VSP-37
July 7, 1982

VENDOR SERVICE PUBLICATION

Subject: Bendix Service Bulletins 615, 620, 621

Figure 1

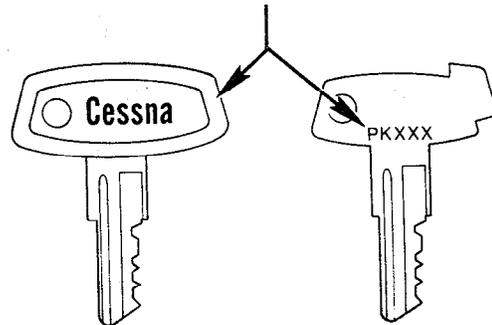
NOTE: The key PK number is located on the key as indicated in figure 1.

Key PK number stamped in this area.

Have to remove black rubber from top of key to expose the PK number.

Figure 1. 10-157197 Distributor Gears with Different Timing Marks

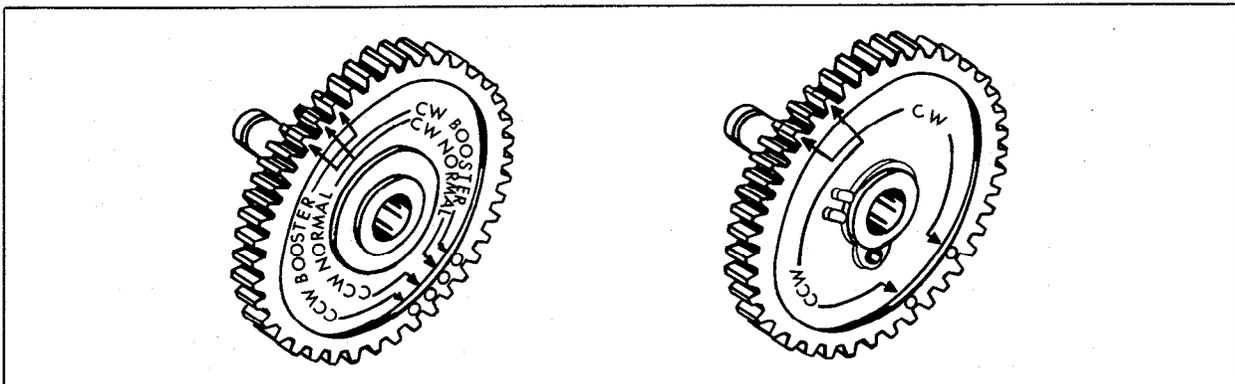
2. If old distributor gear, P/N 10-157197, which incorporated two different molded timing identification marks was used (see figure 1), proceed as follows:

- a. Remove paint from booster timing positions with suitable solvent.
- b. Locate normal timing tooth between CW and CCW booster chamfered teeth and paint this tooth and the applicable inner timing mark with red Dykem or red lacquer in accordance with figure 2 or figure 4 for appropriate gear.

Figure 3. Timing Marks on Present Production Distributor Gear Kit Assembly 10-357586

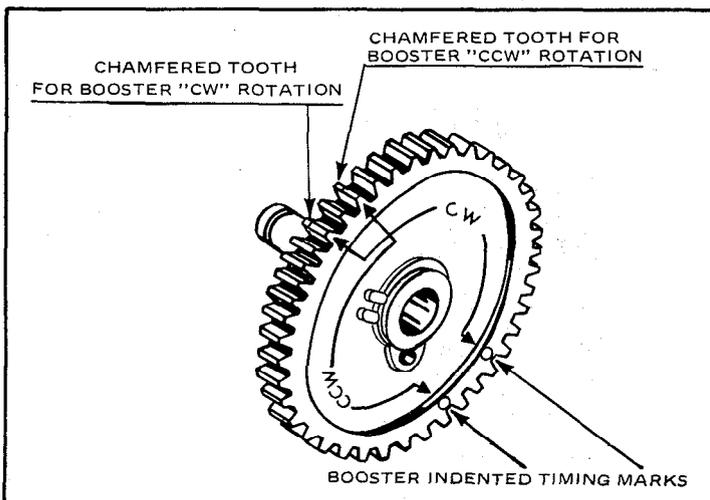
3. If present production distributor gear as supplied in kit P/N 10-357586 is used (see figure 3) proceed as follows:
 - a. Remove paint from booster timing positions with suitable solvent.
 - b. Locate normal timing tooth between CW and CCW booster chamfered teeth and paint this tooth and the applicable inner timing mark with red Dykem or red lacquer in accordance with figure 4.

Figure 4. Present Production Distributor Gear Assembly with Additional Timing Marks Painted

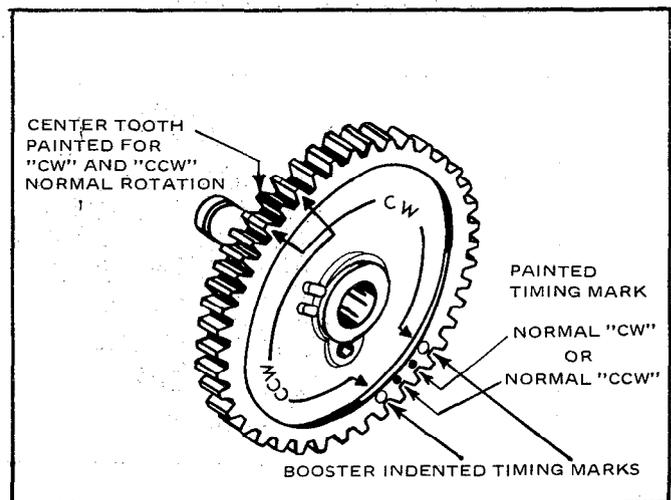
The molded timing marks incorporated in new present production nylon spare part gears, as supplied in kit, P/N 10-357586, are for the booster timing position. Before installation of a new gear kit, the applicable normal timing mark and center tooth must be marked with red

Dykem or red lacquer as illustrated in figure 4.

Original Gear Make Up
(Not incorporating insulating or plain steel skid washer.)
Figure 1

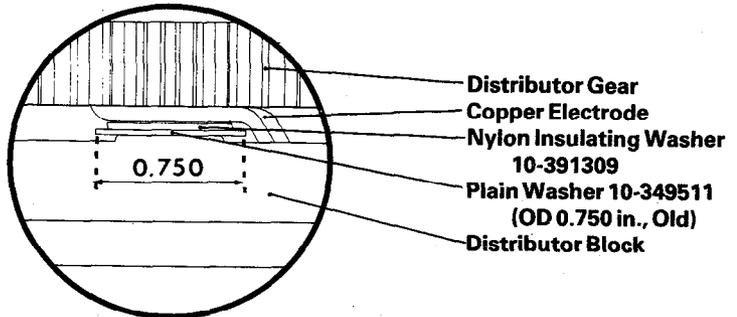
1. Remove the top timing plug.
2. Using a concentrated light beam (a pen light or equivalent) look into the timing hole at the area between the distributor gear and the distributor block parts for existing washer configuration.
3. Current configuration should be as shown in figure 3.
4. Rework magneto whenever configuration is as shown in figure 2.
5. An acceptable configuration is shown in figure 1.

Insulated Gear Configuration
(Incorporating 10-357586 Kit parts with incorrect washer.)
Figure 2

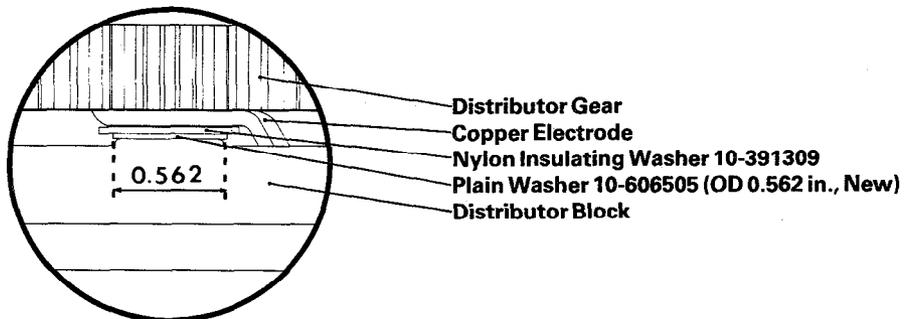
It has been determined that plain steel washer P/N 10-349511 installed on the gear axle between the nylon-insulating washer P/N 10-391309 and the distributor block bronze oil-lite bushing (see figure 2) can cause electrical flash-over in the distributor at altitude. Inspect for compliance as follows:

1. Remove magneto from engine.
2. Disassemble as required using procedures described in Bendix Overhaul Manual Form No. L-205-10 for S-20 and L-527-4 for S-200 series magnetos.
3. Remove retaining ring and plain washer. Discard retaining ring. Remove distributor gear from the distributor block.
4. Inspect the distributor block for burning or carbon tracking and serviceability. Replace if defective.
5. Remove old plain steel washer P/N 10-349511 (OD 0.750 in.) and nylon insulating washer P/N 10-391309 from the gear axle.
6. Reinstall nylon insulating washer P/N 10-391309 and install new plain washer P/N 10-606505 (OD 0.562 in.) on gear axle. See figure 4 for assembly order.
7. Wipe distributor gear axle clean, then reinstall it in the block. Place plain washer P/N 10-349511

on axle shaft and secure with new retaining ring P/N 10-92815-37.
